SERVICE BULLETIN

APPLICABILITY: 2015-16MY Legacy and Outback Models Equipped with Navigation and Harman Kardon Power Amplifier **NUMBER:** 15-194-16R
SUBJECT: Fujitsu 10/ FTEN/ F10 Navigation Voice Guidance Instructions Getting Cut Off **DATE:** 02/29/16
REVISED: 08/22/18

PRODUCTION CHANGE INFORMATION:

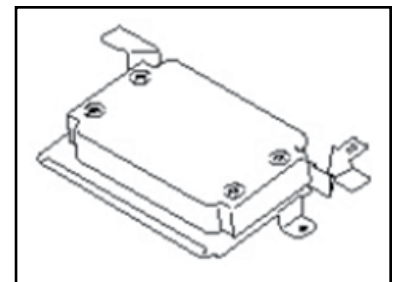
This bulletin announces availability of an enhanced audio system power amplifier which contains software to address customer concerns of voice guidance instructions (words) being cut short or cut off. For example: instead of the instruction saying “Turn right ahead”, it might be “right ahead” or even just “ahead”. This intermittent condition occurs after completing a Bluetooth hands-free phone call while using the navigation system’s voice guidance feature. **The new software also stops the Voice Guidance tone setting (as selected by the customer) from intermittently returning back to the system’s default setting.**

The new power amplifier part number is **86221AL71B**.

IMPORTANT: Power amplifiers which have part number 86221AL71B on the identification label as shown in the photo at the top of page 2, already contain this new software.
